# ***Brynwood Golf & Country Club***

568 Bedford Road  
Town of North Castle  
Westchester County  
New York

*Date Submitted: October 31, 2014*

*Date Revised: March 31, 2015*

**Fracture-Trace Analysis and Offsite Well Monitoring Program**

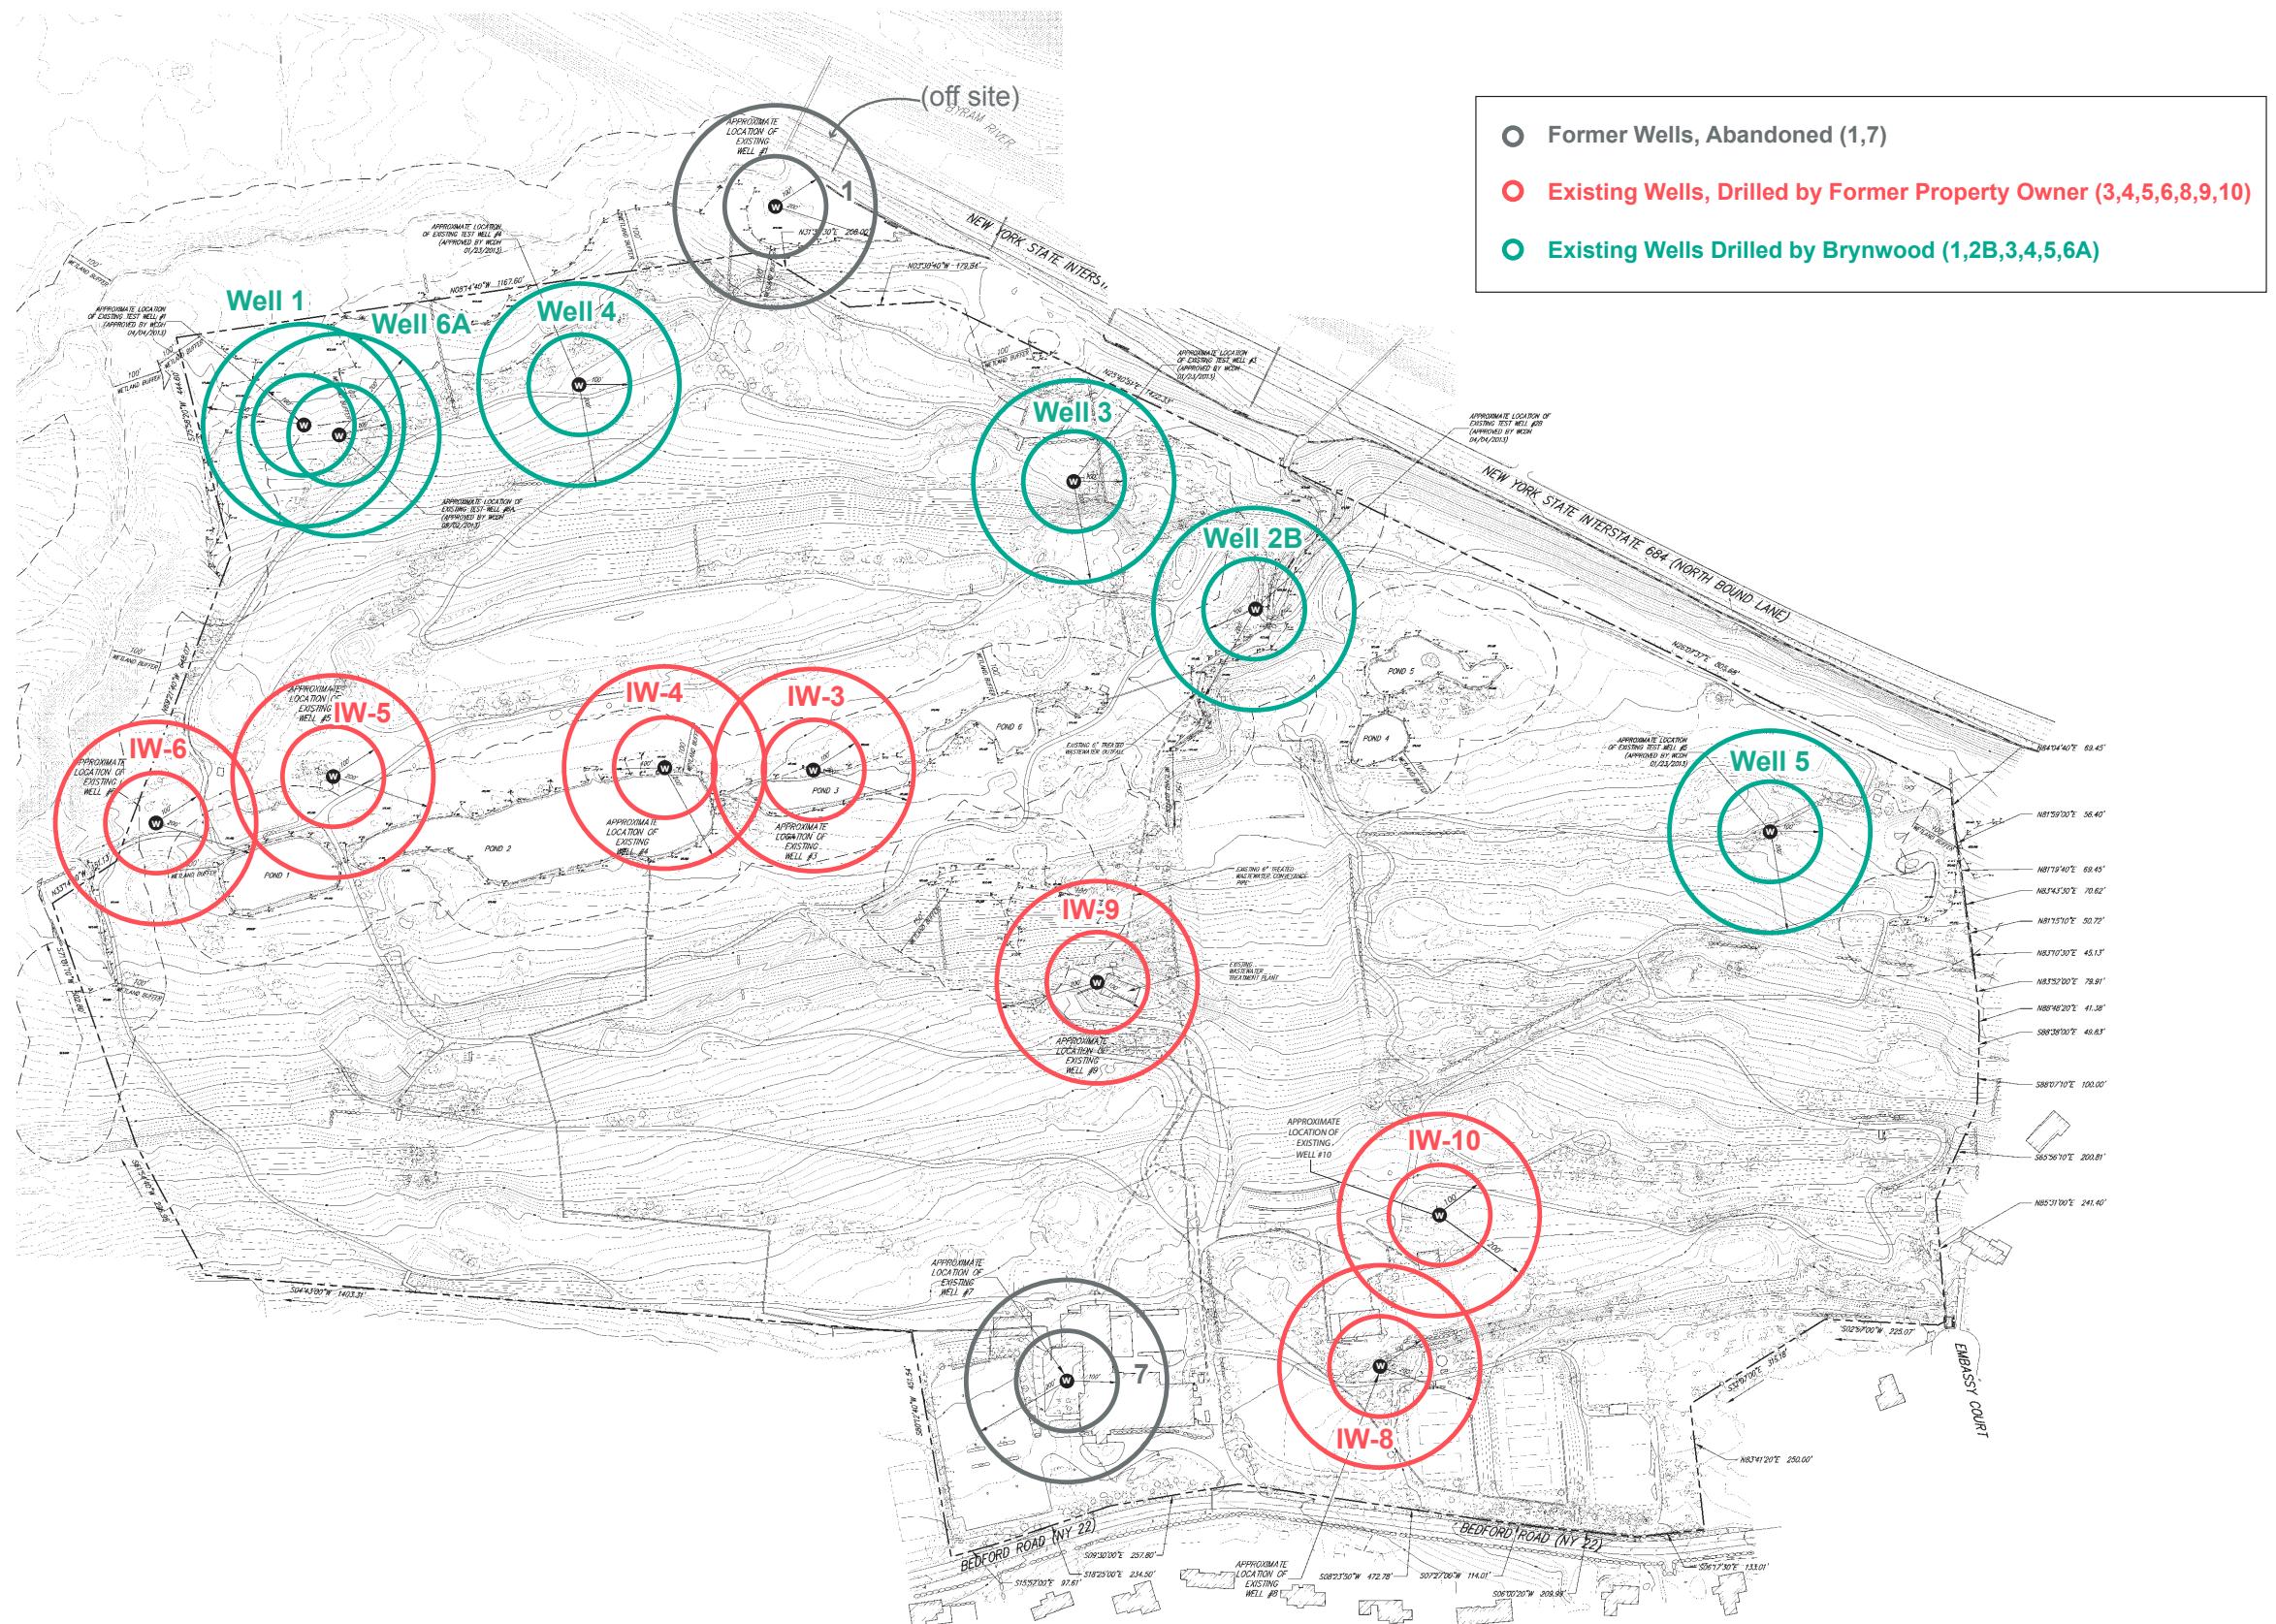
*We have reviewed this 'Complaint Response' letter and agree with the observations and conclusions made by LBG. In short, based on the information presented, we do not believe that the pumping test program executed at the Brynwood Golf & Country Club in May 2013 adversely impacted the well at #8 Embassy Court.*
